Victorian Society Testimony for May 6, 2025: Central Park - Scenic Landmark - Perimeter at East 103rd Street, Manhattan (LPC-25-07995); -- Governors Island, Building 19 (LPC-25-09619); 432 Lafayette Street - 432 Lafayette Street Building - Individual Landmark (LPC-25-09295); 11 Bond Street (LPC-25-07909); 1466 Broadway - The Knickerbocker Hotel - Individual Landmark (LPC-25-08773); 20 West Drive, Prospect Park (signs for Vale area) (LPC-25-08170); 956 Park Place (LPC-25-08411)

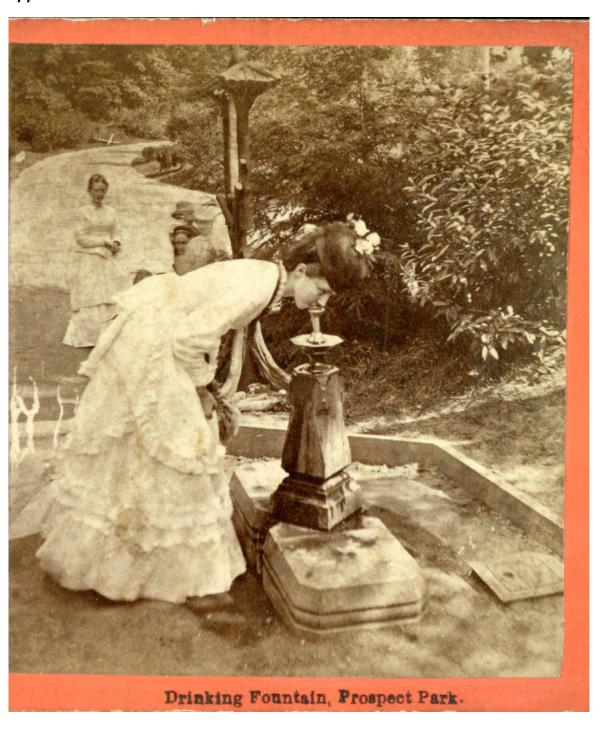
First, there are too many signs. Every time an object like this is put in the landscape, it chips away at the park's purpose of imitating nature and spiritually removing the visitor from the outside world. That's why the original park signs were rustic or picturesque, to blend with the landscape. The Alliance has unaccountably not included any views of historic signs in their presentation, so we have attached some to our written testimony. Rustic signs could be reproduced today using durable materials.

Second is placement. As our pictures show, signs were placed parallel to paths, so they would not call attention to themselves. The mockup images show that the applicant has done exactly the opposite. In Olmsted parks the visitor is meant to walk along a path, drawn towards landscape views of varying types and degrees of mystery. It's absolutely wrong to have landscape vistas disrupted by colorful signs.

Note how the large rustic sign blends with the naturalistic landscape. Also note that it is parallel to the path, minimizing its effect on views as visitors move through the landscape. Such signs could be recreated using durable cast materials.

Two historic signs are seen here, one in the left foreground and one in the center, being read by the man on the bicycle. Again, note that the design and placement minimize disruption of views and naturalistic landscape.
